REVISED 5/8/15 TO INCLUDE ADDITIONAL BANK STABILIZATION AND TOPSOIL ON TOP OF PREVIOUS AREA OF BANK STABILIZATION

AUTHORIZATION TO CONDUCT STREAM ALTERATION ACTIVITIES

Project Number: SA-SE-063-2014 (2013) JAMAICA KIERAN COSTELLO DEBRIS REMOVAL

ANR-DEC-WQD-RIVER MANAGEMENT PROGRAM FIELD FORM

Field sketch:

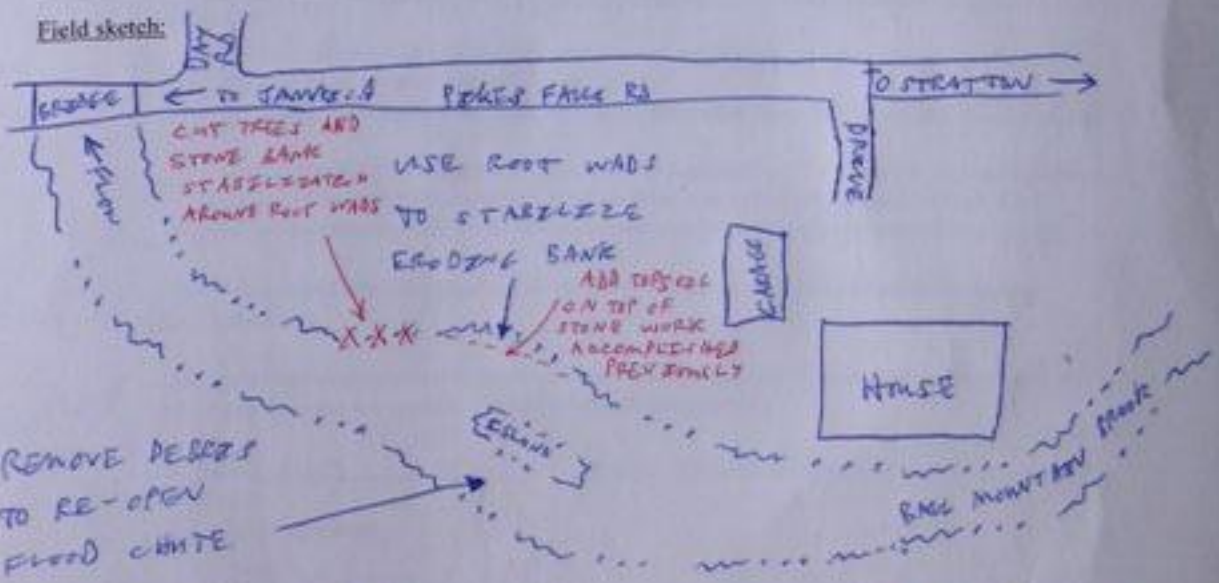
REMOVAL OF TREE DEBRIS BLOCKING CHANNEL CONVEYANCE TO RE-OPEN FLOOD CHUTE & USE ROOT WADS TO STABILIZE ERODING BANK
